UNITED STATES PATENT AND TRADEMARK OFFICE

10/580,091

Jurgen Oetjen

Office Action Summary	Application No. 10/580,091	Applicant(s) OETJEN, JURGEN	
	Examiner Thomas Diaz	Art Unit 4171

Figure i- Applicant's roller screw.

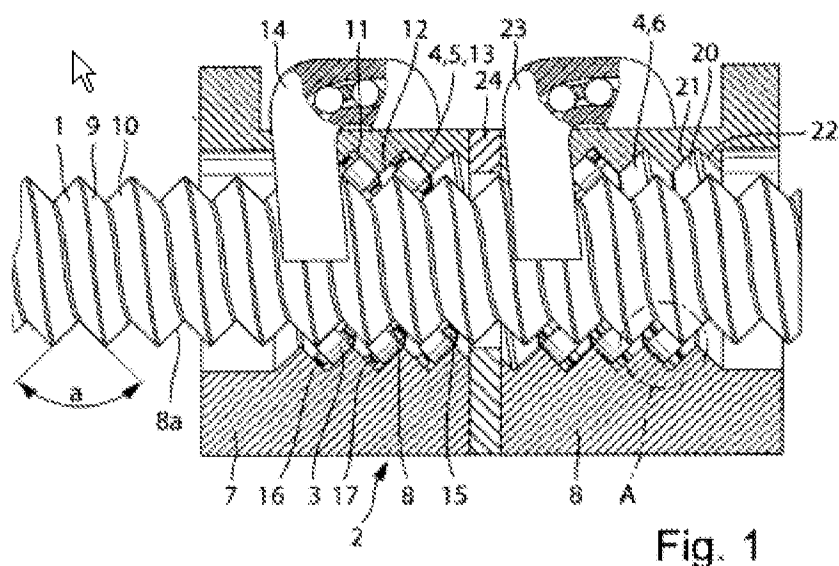
- “a” has been used to designate both an angle in fig.1 and a distance in fig.2.
- “8” has been used to an unspecified area in fig. 1 and a 2nd nut part in fig.1.

- Reference numerals (4,5,13) in figure 1 are pointing to one location and referencing multiple parts. It is unclear how to distinguish the parts.

- In claims 4 and subsequent dependent claims from 4, the applicant claims a cage having belts which have webs and also claims pockets. These features are labeled in the drawings as the same thing. It is unclear to the examiner where exactly the features are shown. These features should be distinguished so that they are clearly shown in the figures.

Figure ii- Nishimura et al.'s roller screw.

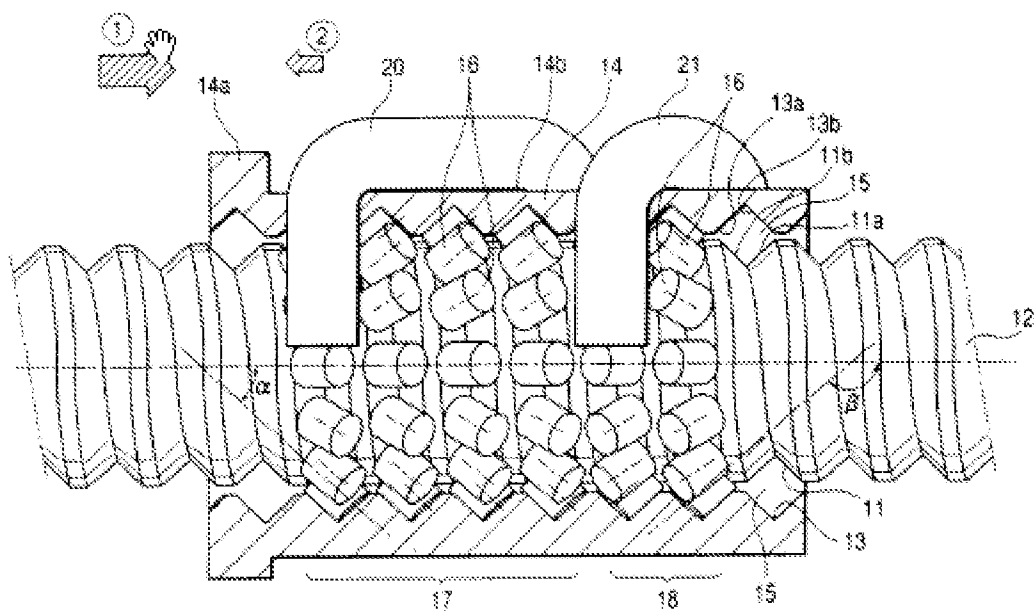
Nishimura et al. discloses a similar roller screw to applicant’s roller screw, both seen below:

- A spindle nut (fig.1, 14) arranged on a threaded spindle (fig.1, 12),
- Rollers (fig.1, 16) which are arranged such that they can roll in a thread path (fig.1, 15),
- The thread path being delimited by thread grooves (fig.1,13, 11) provided on the threaded spindle and on the spindle nut,
- Wherein two equal pitches of the thread grooves are arranged so as to be axially offset with respect to one another by a partial amount of the pitch.

Figure iii- Nishimura et al.'s device.

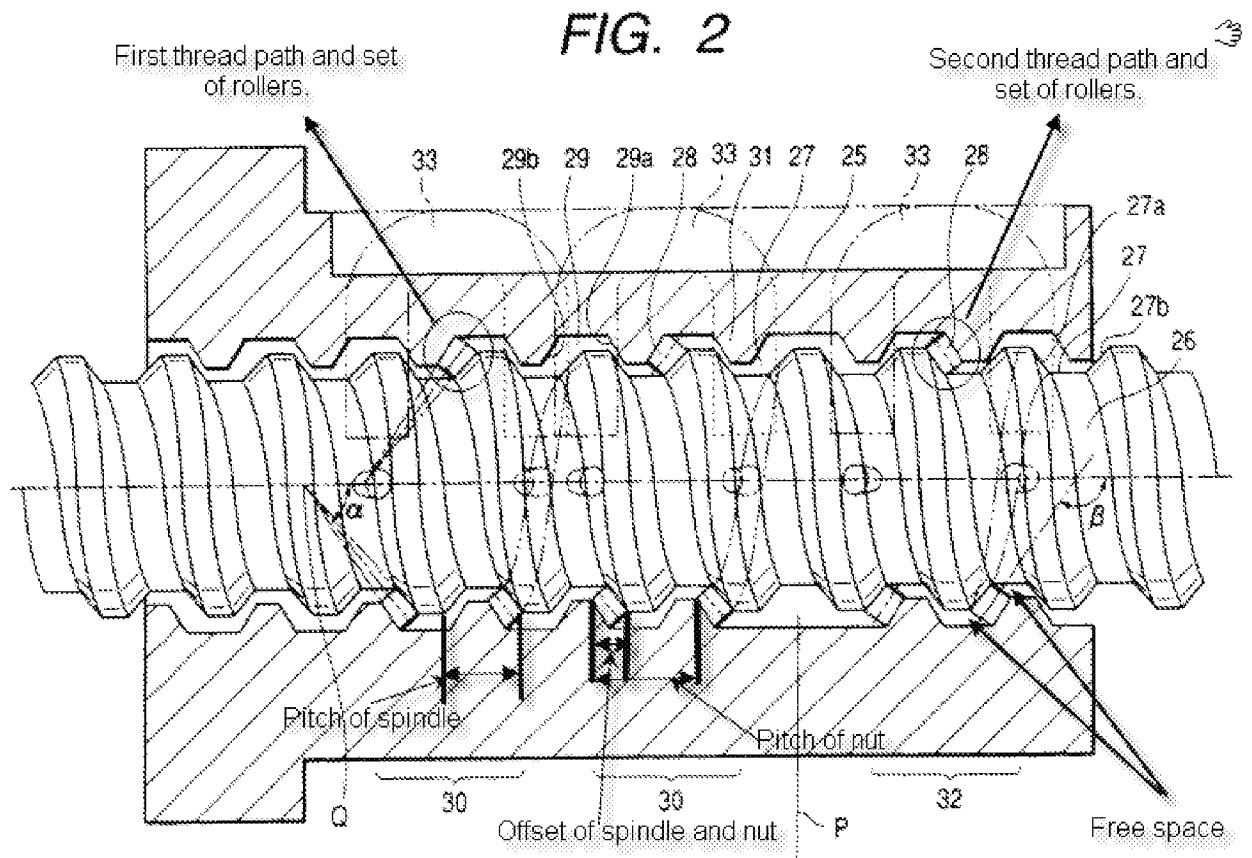
(This is seen in figure 2, below.)

This is labeled in figure 2. Both sets of rollers are on different thread paths or different flanks.

This is also clear from figure 2, according to the labels of the first and second sets of rollers made by the examiner.

This is also clear from the labeled portions in figure 2. Both sets roll on a different set of flanks.

The two thread flanks of the thread groove are perpendicular to each other as taught col.5, lines 64-67. From figure 2, the partial amount labeled is approximately 30% of the absolute value of the pitch.

Figure iv- Ise's device.

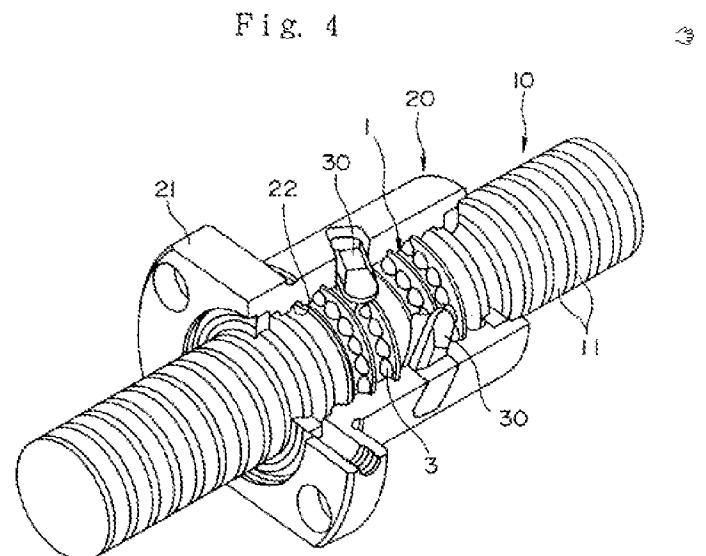
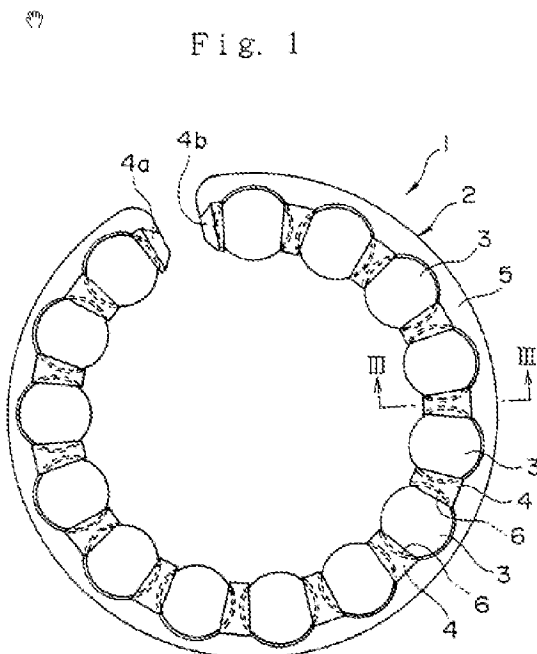
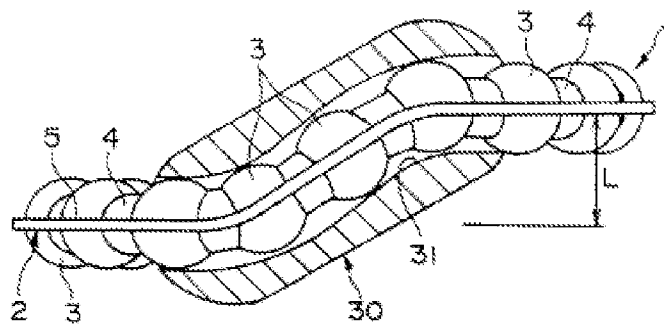
Ise teaches a cage (fig.1, 1) having belts (fig.1, 4) and webs (fig.1, 5) which connect the rollers to each other. This structure is used to provide smoother circulation of the rollers (col.2, lines 30-33).

Ise teaches the belts arranged at a distance from one another and span one plane, the rotational axis of the rollers being parallel to the plane and transversely with respect to the belts as seen in fig. 10.

Ise teaches the web looping around the rotational axis of the roller screw drive in the manner of a screw as seen in figure 4 for the purpose of connecting all the rollers.

Figure v- Greby's roller screw.

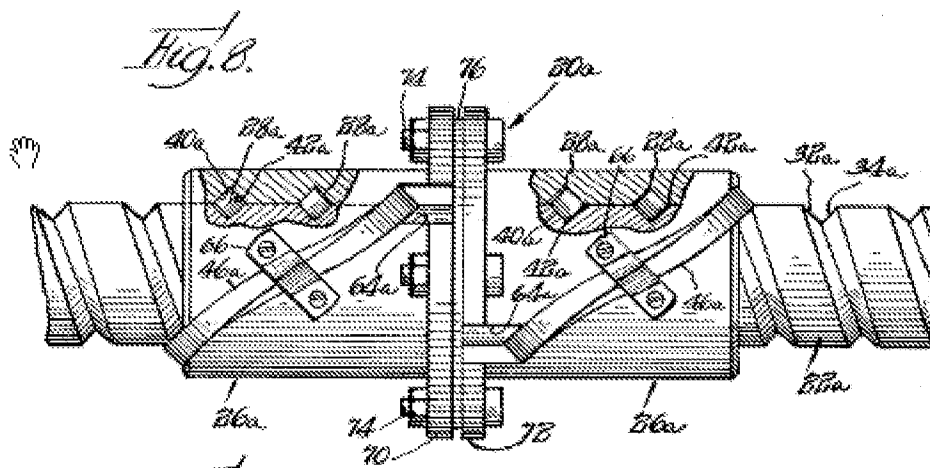
Greby teaches nut parts both labeled 26a in figure 8 and mentioned col.5, lines 24-29, where Greby further discusses these nut parts allow for sustaining thrust loads in two directions.

Greby teaches a spacer (fig.8, 76) for the purpose of preloading the rollers and eliminate axial play of the nuts on the screw (col.5, lines 35+). This shim can be adjusted.
